CALL NO. 107
CONTRACT ID NO. 131084
Addendum # 2

Subject: Henderson County, STP 9004 (030)
Letting December 13, 2013

(1) Revised - Plan Sheets - R2, R2E

COUNTY OF	ITEM NO.	SHEET NO.
HENDERSON	2-8304.00	R2

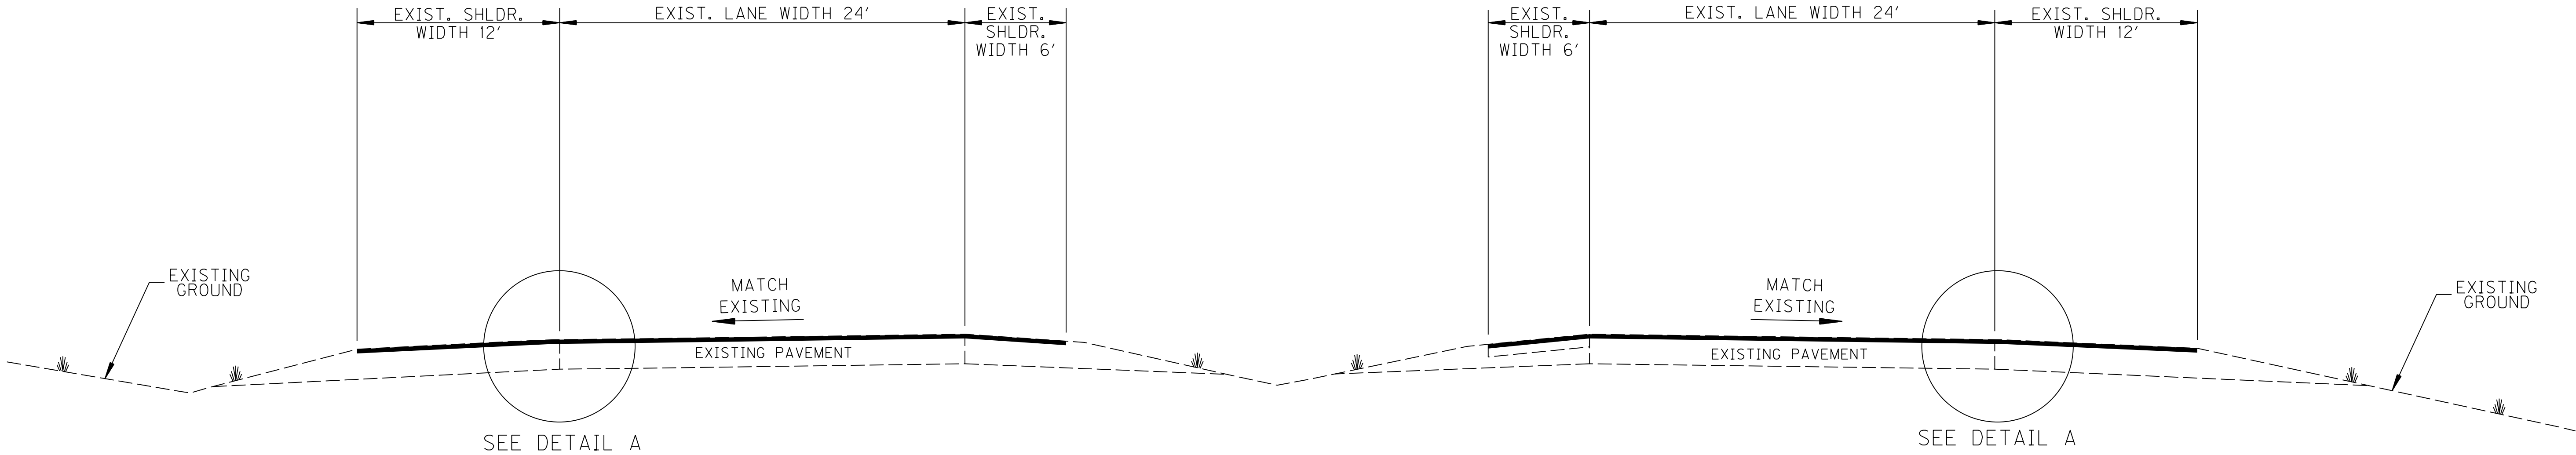
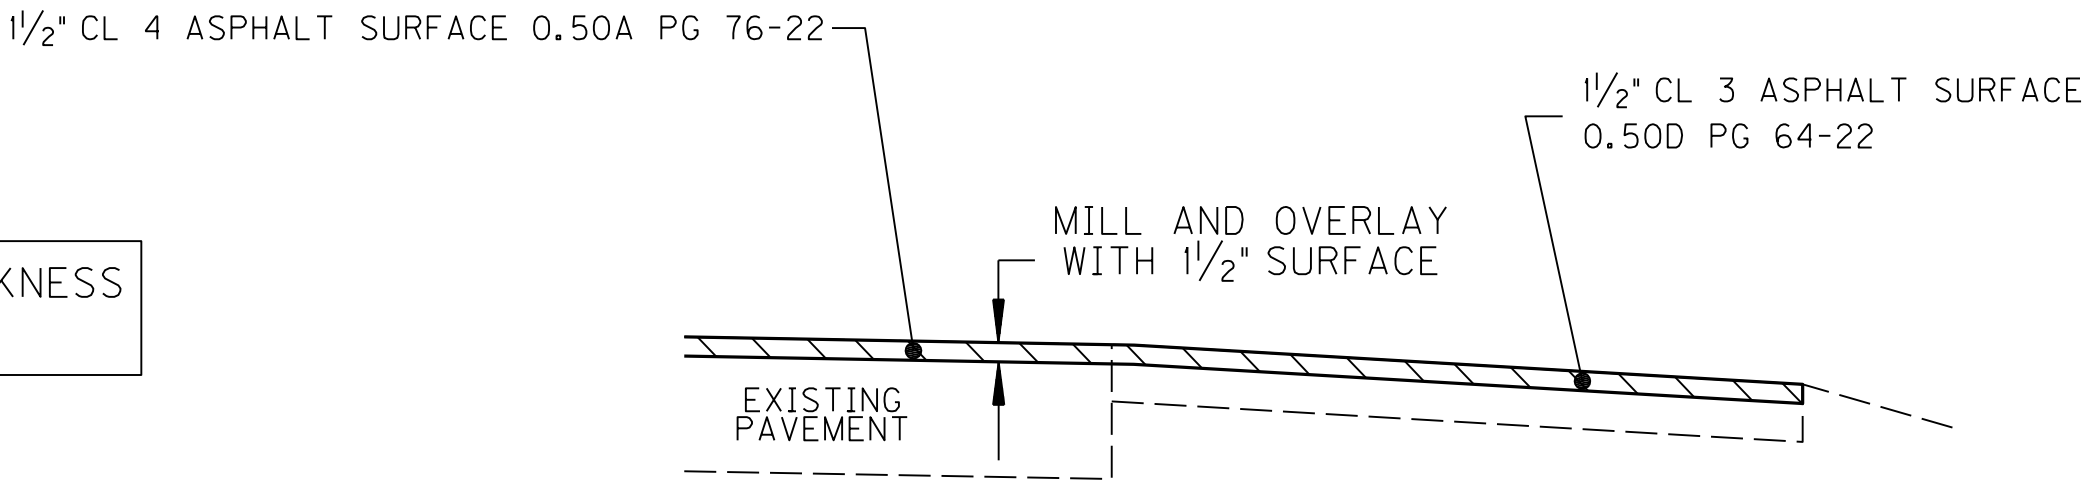
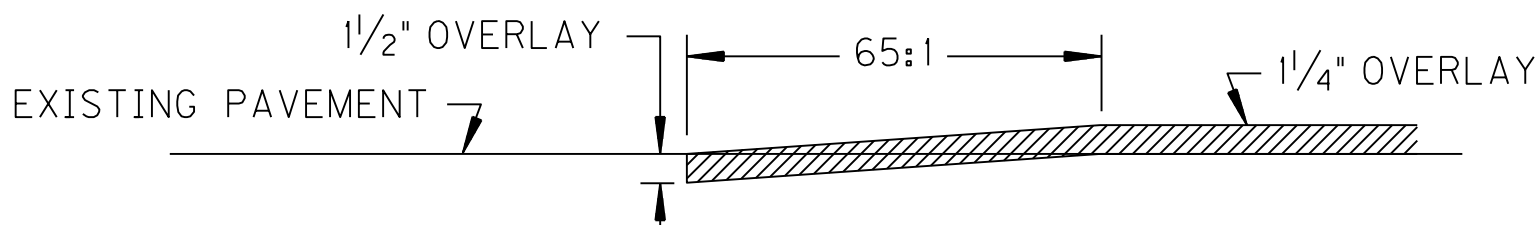
REVISION (12-3-13): CHANGED MIX ON SHOULDERS
TO 1 1/2" CL 3 ASPHALT SURFACE 0.50D PG 64-22

COUNTY OF	ITEM NO.	SHEET NO.
HENDERSON	2-8304.00	R2

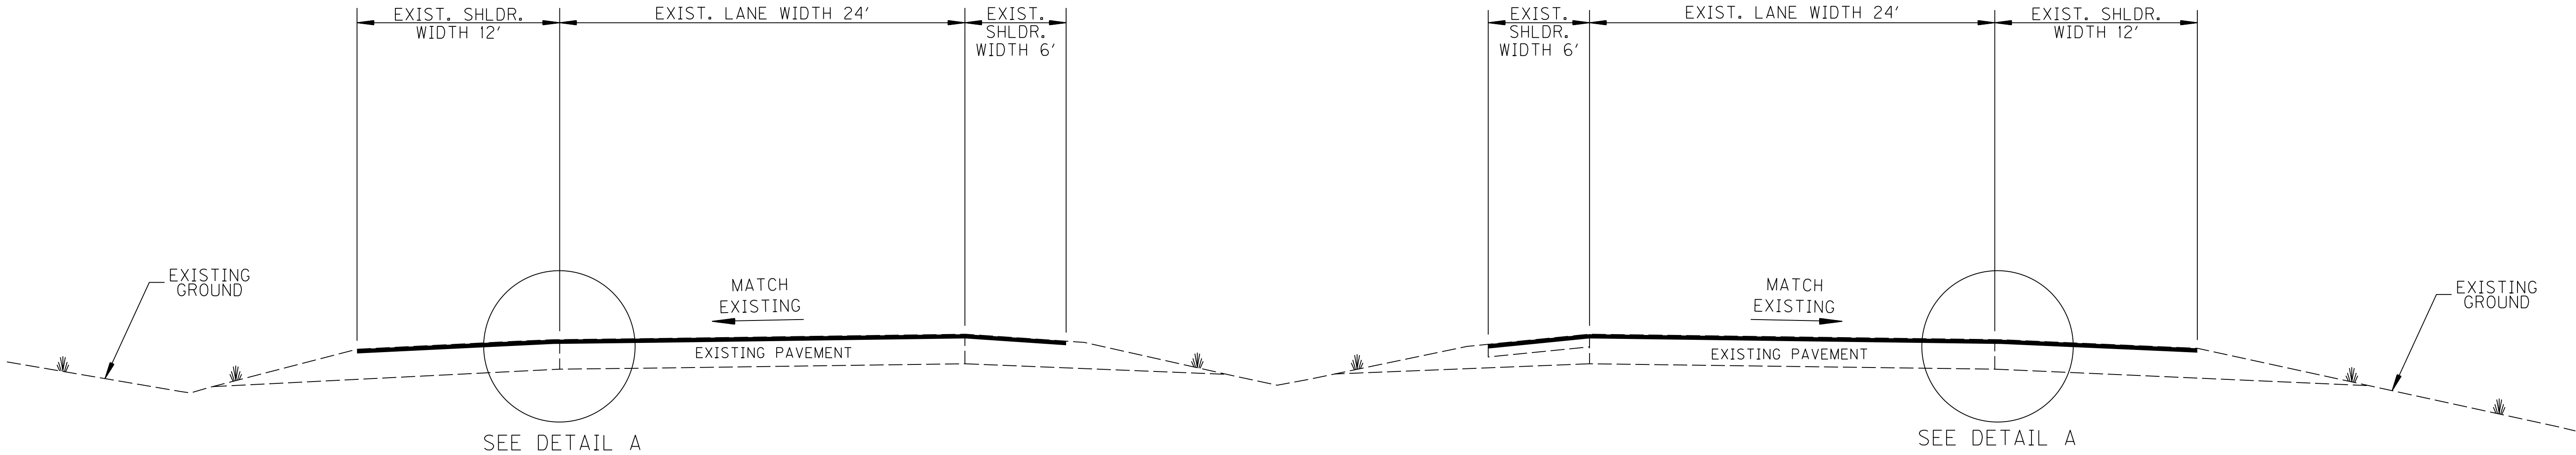
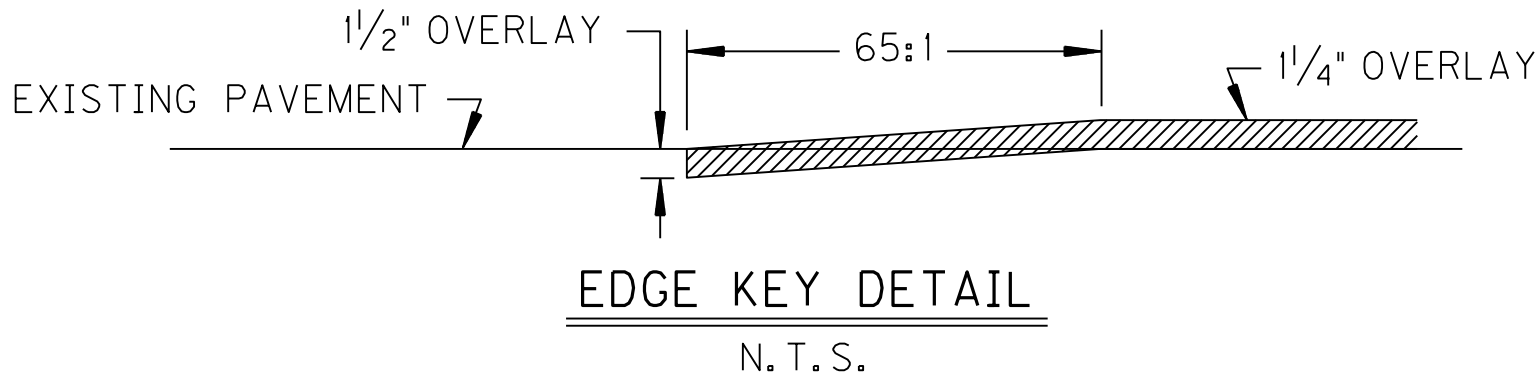
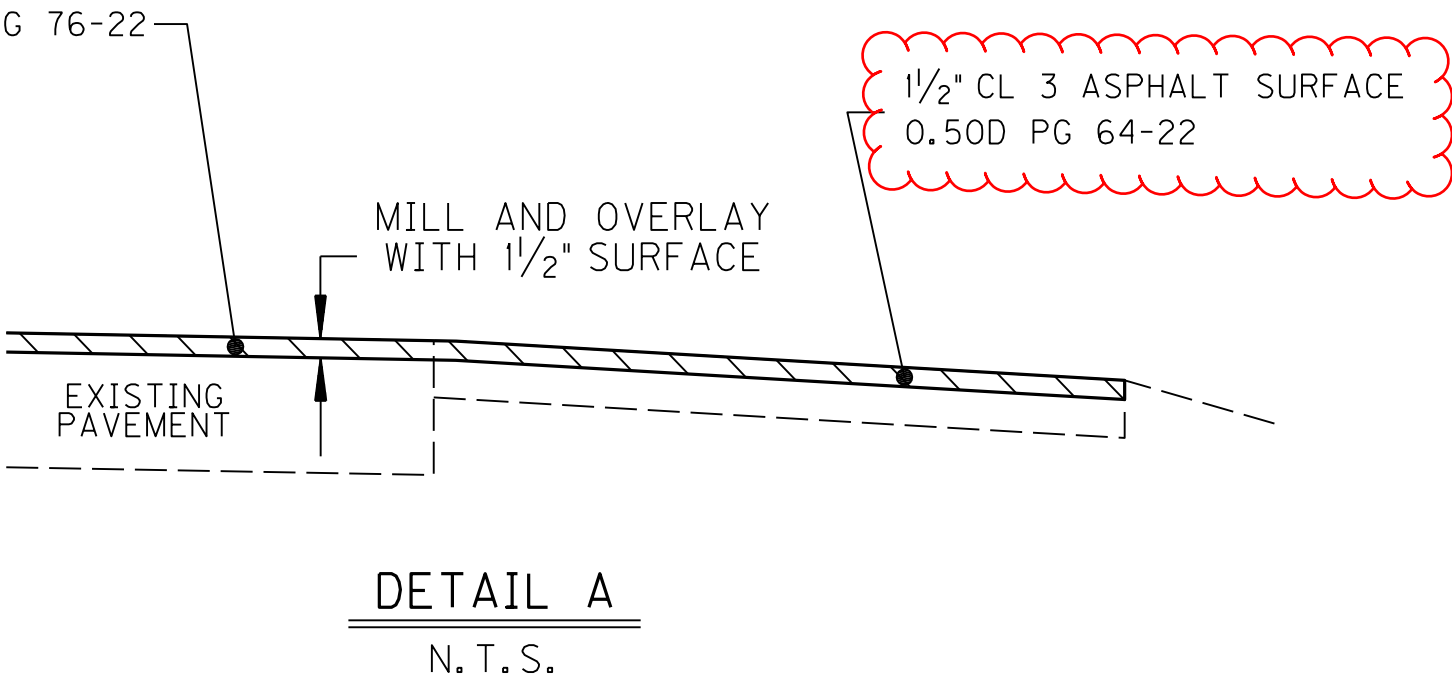
REVISION (12-3-13): CHANGED MIX ON SHOULDERS TO 1 1/2" CL 3 ASPHALT SURFACE 0.50D PG 64-22
